RESPONSE TO REQUEST FOR ADDITIONAL INFORMATION

US-APWR Design Certification

Docket No. 52-021

RAI NO.: NO. 960-6709 REVISION 3
SRP SECTION: 03.07.02 – Seismic System Analysis
APPLICATION SECTION: 3.7.2
DATE OF RAI ISSUE: 09/24/2012

Figure A3-1 Effect of adjacent structures on lateral earth pressures acting on the below-grade walls of the R/B Complex

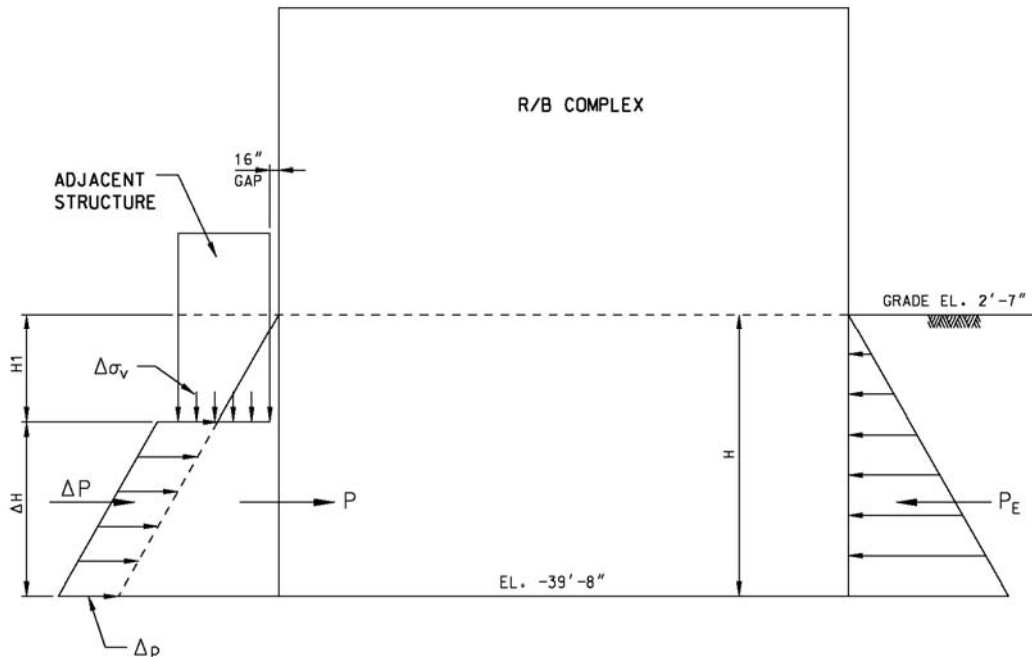
f) Assumption 4 in the TR indicates that embedment effects (active and passive pressures) are neglected during sliding. The applicant is requested to explain how the effects of surcharge loads due to adjacent structures will be considered in the sliding stability analyses.

The lateral earth pressures from embankment acting on the below grade walls of the R/B Complex and accounting for surcharges from adjacent structures are schematically presented in Figure A3-1. The pressures are marked by lower case letters and the thrust forces per unit length of wall are marked by upper case letters. For the cases of interest here (Case 1 - no sliding, and Case 2 - sliding, discussed in the answer to Question 03.07.02-216(f) of this RAI), the notations in Figure A3-1 are as follows:

The vertical stress induced by the AC/B at its basemat (3.03ksf) is smaller than the vertical effective stress in the embankment at that elevation (4.24 ksf), therefore this structure does not produce any increase in lateral earth pressures acting on the R/B Complex. The forces from lateral embankment pressure for the tank house are as follows:

Case 1: No sliding. $\Delta p = k_0 \Delta\sigma_v = 0.19 \text{ ksf};$
 $\Delta P_0^{TH} = \Delta p \Delta H = 5 \text{ kip/ft};$
 $P_E \geq P_0 = \frac{1}{2} k_0 \gamma H^2 = 55.8 \text{ kip/ft}$

Case 2: Sliding. $\Delta p = k_a \Delta\sigma_v = 0.1 \text{ ksf};$
 $\Delta P_a^{TH} = \Delta p \Delta H = 2.6 \text{ kip/ft};$
 $P_a = \frac{1}{2} k_a \gamma H^2 = 30.1 \text{ kip/ft}$
